March 30, 2010
U7-C-STP-NRC-100064

South Texas Project
Units 3 and 4
Docket Nos. 52-012 and 52-013
Response to Requests for Additional Information

RAI 15.08-2 Revision 1**QUESTION:**

RAI 06.02.02-26**QUESTION:**

Figure 15E-1b ATWS Mitigation Logic (SLCS Initiation, Feedwater Runback)

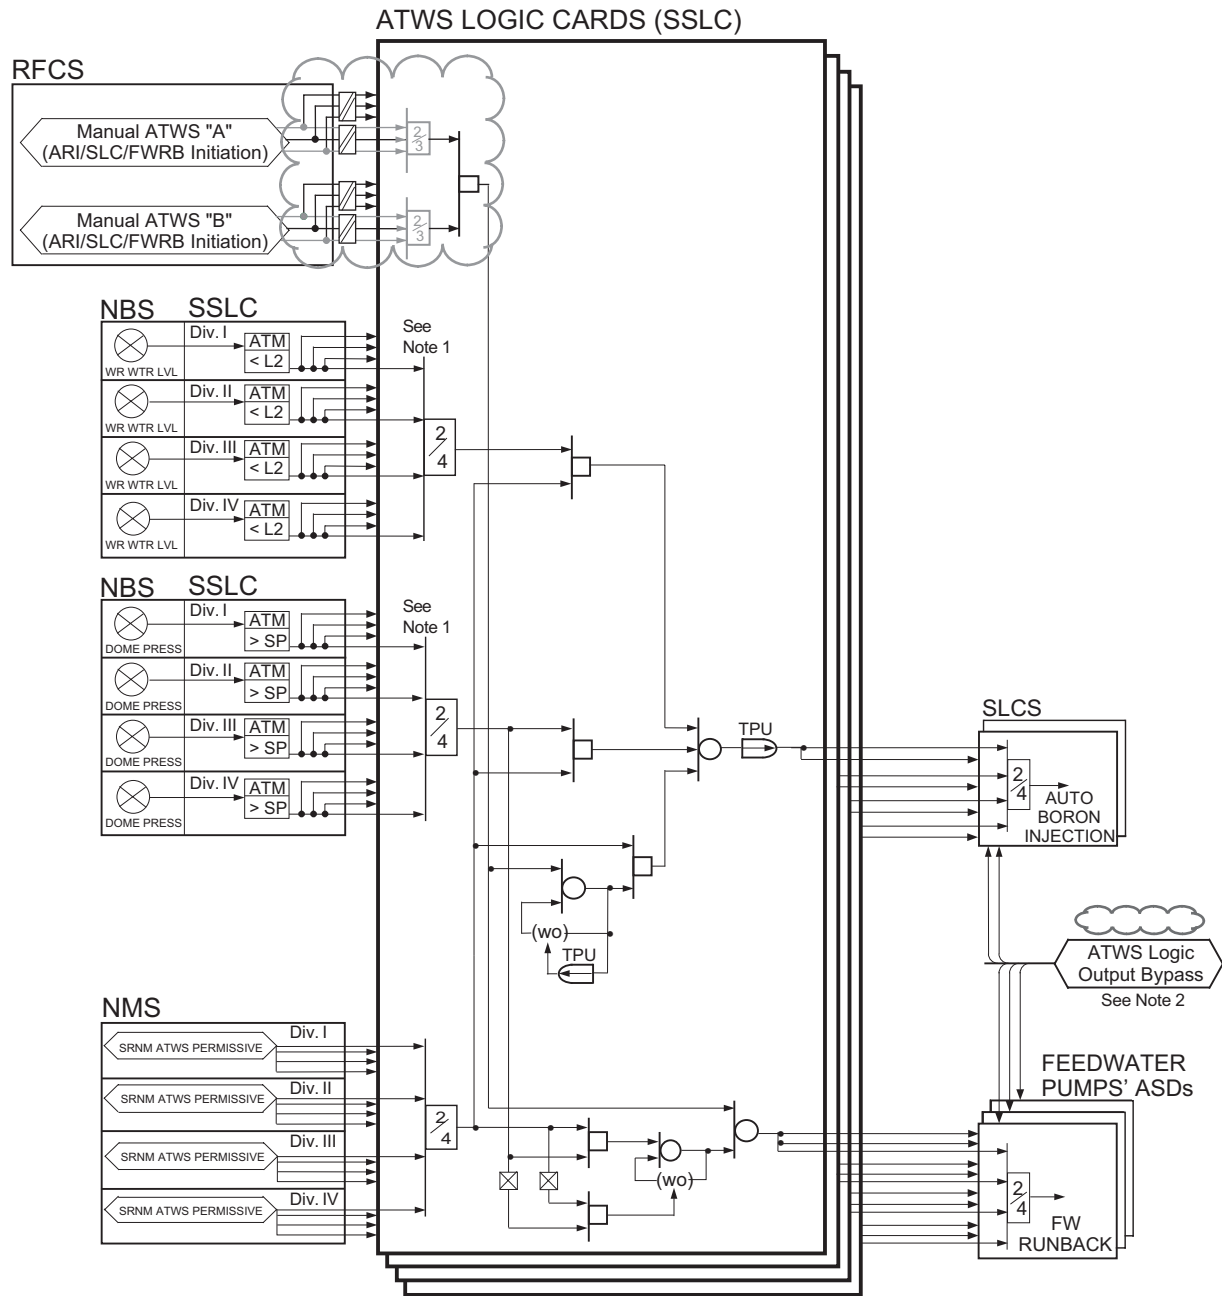
STPNOC has revised the logic in the STP 3 & 4 FSAR Figures 15E-1a, "ATWS Mitigation Logic (ARI, FMCRD Run-In, RPT, Manual Initiation)," 15E-1b, "ATWS Mitigation Logic (SLCS Initiation, Feedwater Runback)," and 15E-1c, "ATWS Mitigation logic (SLCS Initiation, Feedwater Runback)" based on Tier 1 departure STD DEP T1 3.4-1 and STD DEP Admin. However, no changes have been made to the ATWS logic-related text contained in the FSAR, specifically subsections 2.2.8 and 3.4 in Tier 1, and subsection 7.4 and 15E.1 in Tier 2. Explanation of the logic changes shown on these revised FSAR figures has not been provided in either of the cited departures. It was also noted that some of the changes made to these FSAR figures are not annotated (back circled). Due to the stated reasons, NRC staff is unable to verify the acceptability of the departed ATWS mitigation logic. STPNOC is asked to provide an explanation for all marked and unmarked logic changes shown on the revised FSAR figures 15E-1a, 15E-1b, and 15E-1c.

The following changes are made to DCD Figure 15E-1b. An administrative change is made to the manual ATWS "A" & "B" initiation logic to show 2 out of 3 voting signals. This logic change to the DCD figure is correct with respect to the DCD design; however, it was not properly identified as a change on the previous COLA figure, and will be identified in a future COLA revision as shown below. This logic design is consistent with DCD Part 2, Tier 1, Sections 2.2.4 and 3.4 and Part 2, Tier 2, Subsection 7.4.1.2. An additional administrative change is made to correct the figure number in the title.

A change is made to COLA Revision 3, FSAR Figure 15E-1b to show the DCD NMS SRNM ATWS permissive 2-out-of-4 logic design. This change is also an administrative change for consistency with DCD Part 2, Tier 1, Sections 2.2.4 and 3.4 and Part 2, Tier 2, Subsection 7.6.1.1.

There are several additional changes related to the nomenclature changes identified in standard departure STD DEP T1 3.4-1. The nomenclature for trip logic units (TLUs) has changed to trip logic functions (TLFs), so "SSLC TLU" in Figure 15E-1b Note 2 becomes "TLF". Also, as discussed in STPNOC's RAI 07.02-2 response, the same departure eliminates the SSLC bypass unit as a separate entity; the logic for this unit has been incorporated in the Reactor Trip and Isolation System (RTIS).

COLA Part 2, Chapter 15, Figure 15E-1b will be revised as shown below in COLA Revision 4. All changes are shown relative to the DCD. Corresponding changes to the associated ATWS Technical Specification figures will also be made in COLA Revision 4.
